APPEAL SUMMARY

Appeal ID: 31473	Project Address: 1600 SE 59th Ave
Hearing Date: 4/12/23	Appellant Name: Corey Cliffe
Case No.: B-011	Appellant Phone: 503-231-5631
Appeal Type: Building	Plans Examiner/Inspector: Hend Barghouti
Project Type: residential	Stories: 1 Occupancy: R-3 Construction Type: V
Building/Business Name:	Fire Sprinklers: No
Appeal Involves: Alteration of an existing structure, occ Change from attic to habitable space	LUR or Permit Application No.: 23-010686-RS
Plan Submitted Option: pdf [File 1]	Proposed use: single family residence

stirnkorb Remodel
1600 SE 59th Ave. Portland, Oregon

A1

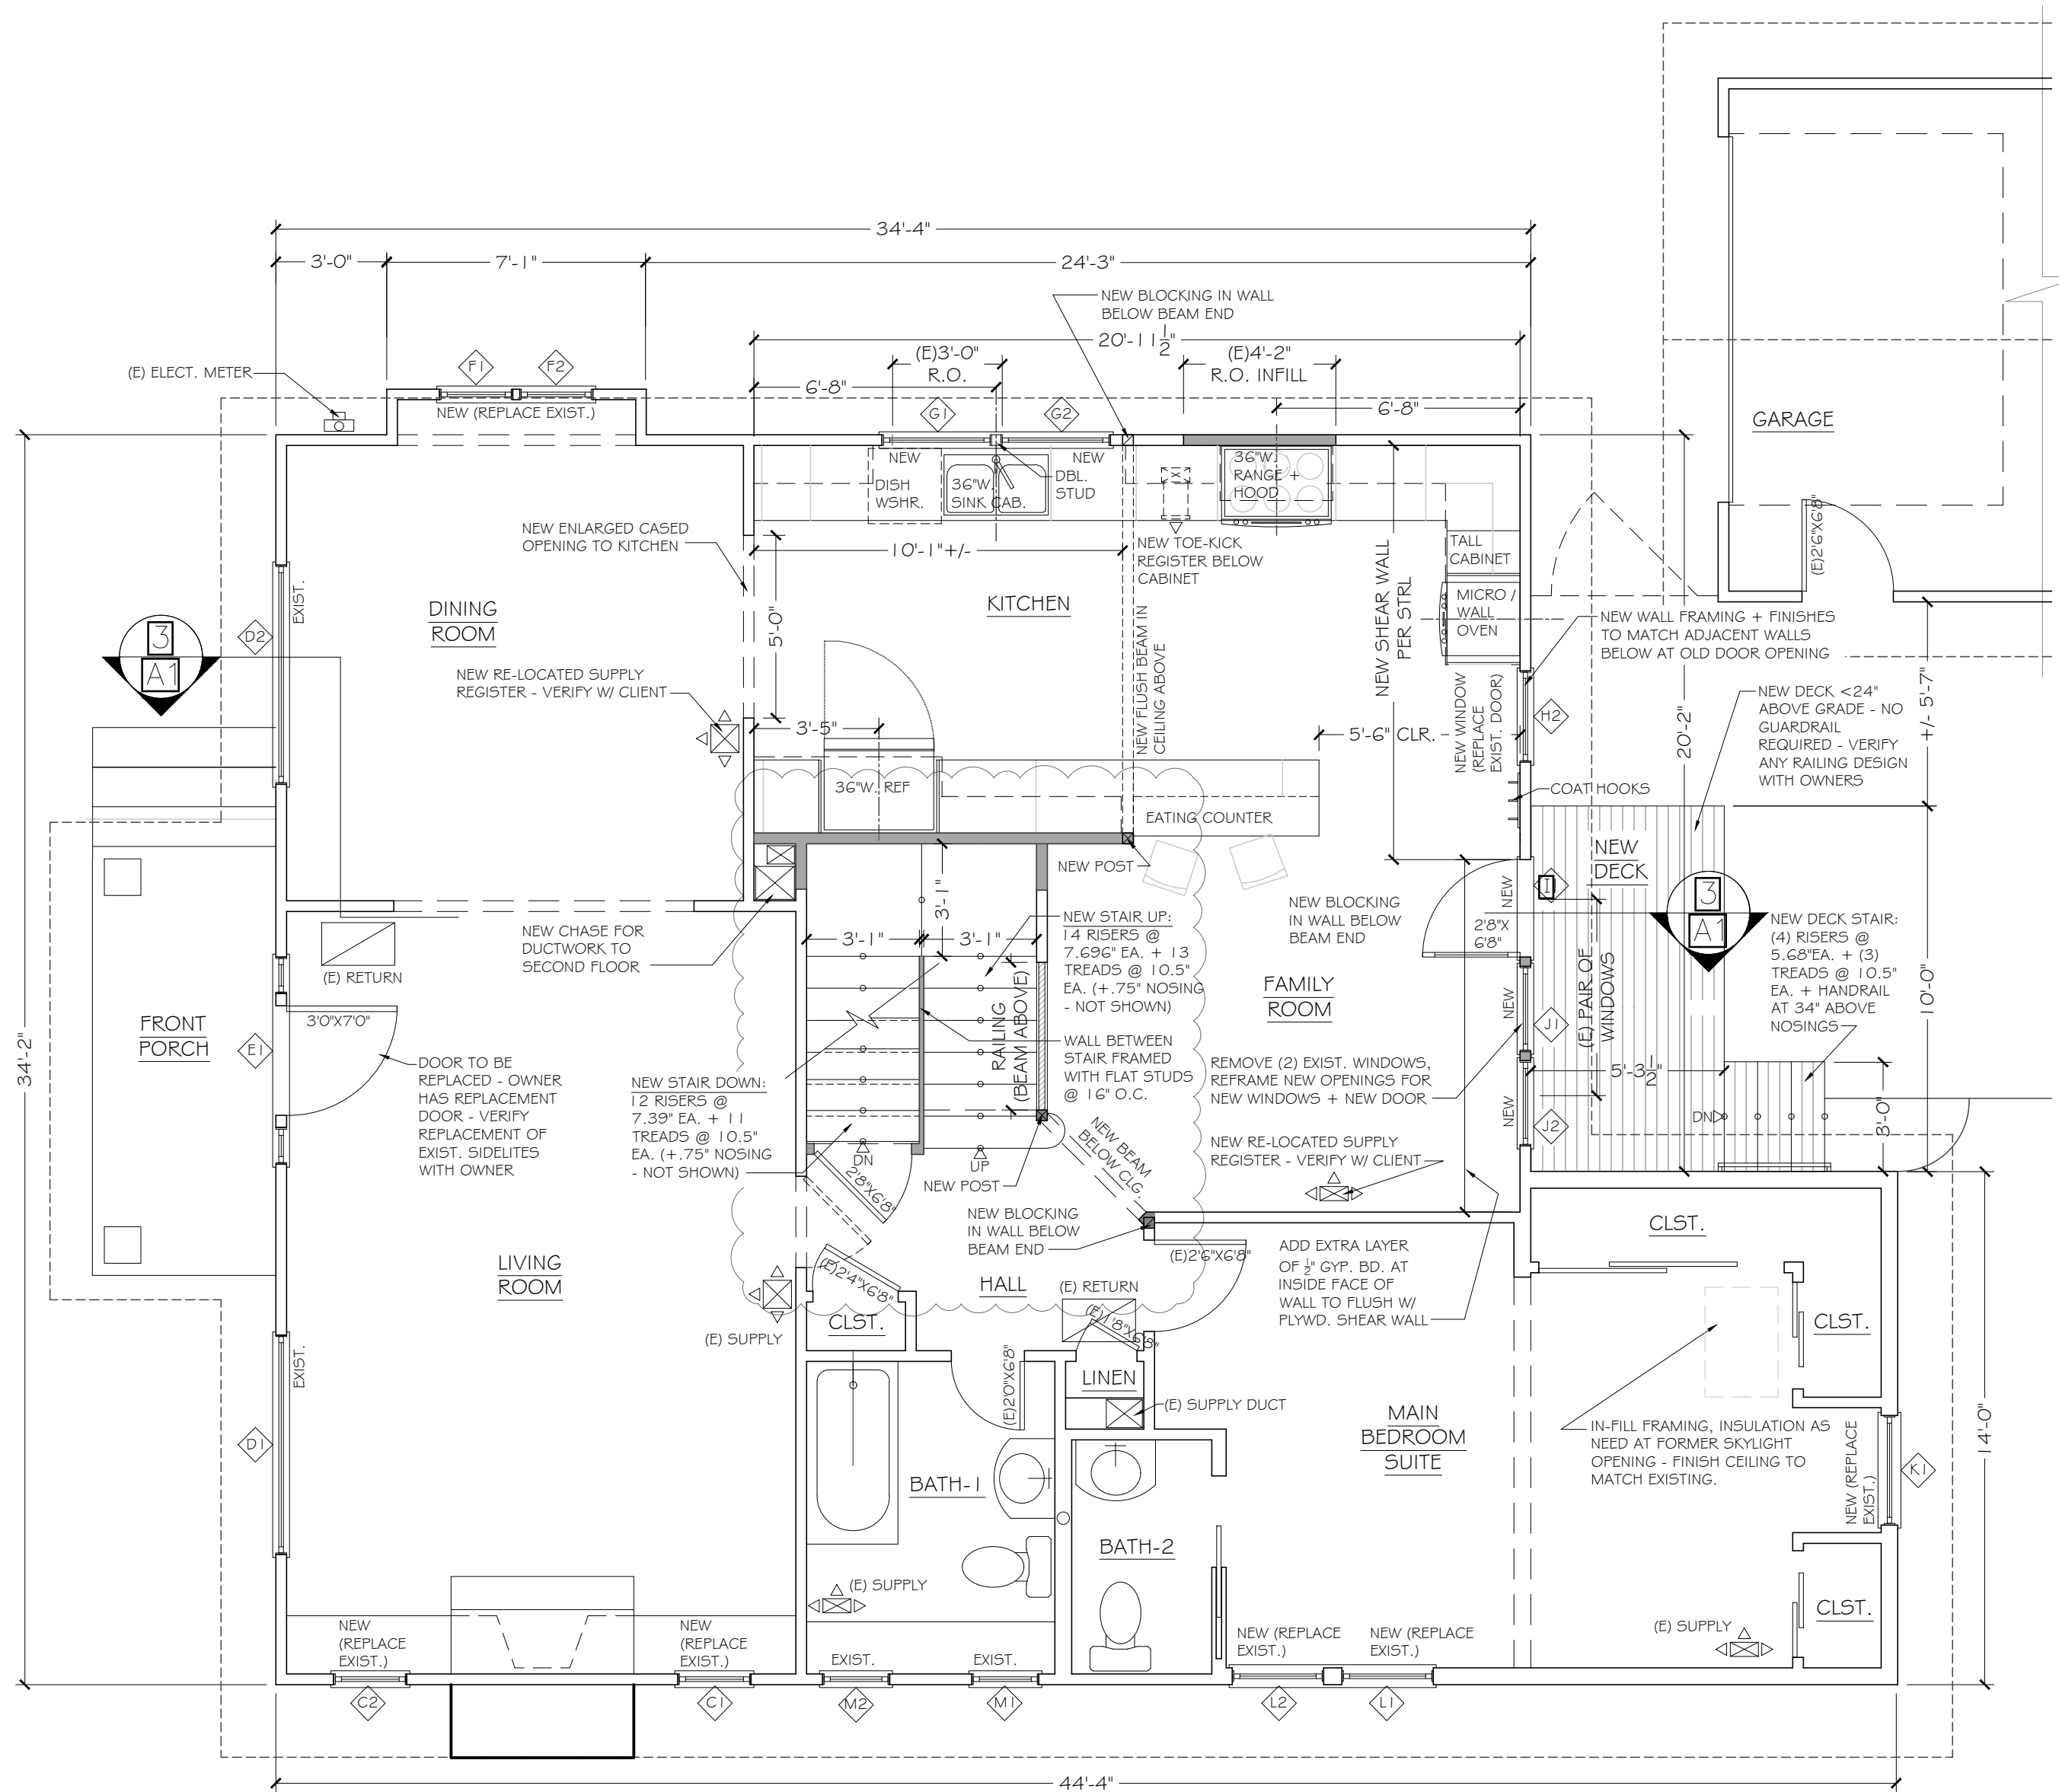
Code Section	ORSC R305.1 Min. Ceiling Heights + Code Guide Brochure 9: Converting Attics, Basements, and Garages to Living Space – Residential.
Requires	Habitable space and hallways shall have ceiling height of not less than 7 feet. Exception 1: Rooms with sloped ceilings, the required floor area shall have ceiling height of not less than 5 feet, and not less than 50% of the required floor area shall have a ceiling height of not less than 7 feet. Exception 5: Conversion of existing non-habitable attics to habitable space shall provide ceiling height of not less than 6'-8" for the portion of ceiling required in Exception 1.
Code Modification or Alternate Requested	Allow the existing hallway ceiling height to remain and be used with the head height as currently built.
Proposed Design	The proposed design re-builds a new stairway in the generally same location as the existing stair opening adjacent to a portion of the upstairs hallway in an attic renovation. This hallway wraps around (2) sides of the new stair in an 'L' shaped fashion to provide access from the top of the stair to 2 new bedrooms. The existing and proposed portion of the hallway in question is 3'-1" wide. The existing hallway ceiling has a flat portion at 7'-7" and a sloped portion on (1) side sloping down to about 5'-7 3/4" at the sidewall. The sloped ceiling intersects the minimum ceiling height of 6'-8" at approx. 1'-10" from the sidewall, leaving the headroom above this remaining 1'-3" width of the hallway above the 6'-8" minimum. The majority of the hallway is adjacent to a 3' high guardrail overlooking the stair. See exhibits 2/D1 & 2/A1 showing the existing and proposed hallway plans, and 3/A1 showing a cross-section of the east portion of the hallway. 1/A2 shows the proposed main floor stair plan for reference. Clouds are used to highlight the areas in question.

Reason for alternative	The existing hallway provides access around the existing and proposed stair opening which is ideally suited for renovation to add (2) bedrooms on either side of the central stair. All other areas

of the attic meet the height requirements with the exception of one portion of the hallway. The entire 'L' shaped hallway exceeds the head height code minimum for 60% of its total area. (See exhibit 2/A1 hallway plan with portion of headroom below 6'-8" with a dark shading for clarity) The hallway does not restrict access and does not present a safety hazard. The sloped ceiling is not a projection into the space (such as a beam or pipe), but more similar to a sloped ceiling in a living space where, per ORSC R305.1 & BDS brochure 9, "no more than half of the minimum required floor area may have a sloped ceiling less than 6'-8" in height with no part of the required floor area less than 5' in height." These requirements are met in the existing and proposed hallway.

Reduction in the minimum required ceiling height at attic level hallway: Denied. Proposal does not provide an equivalent level of Life Safety protection.
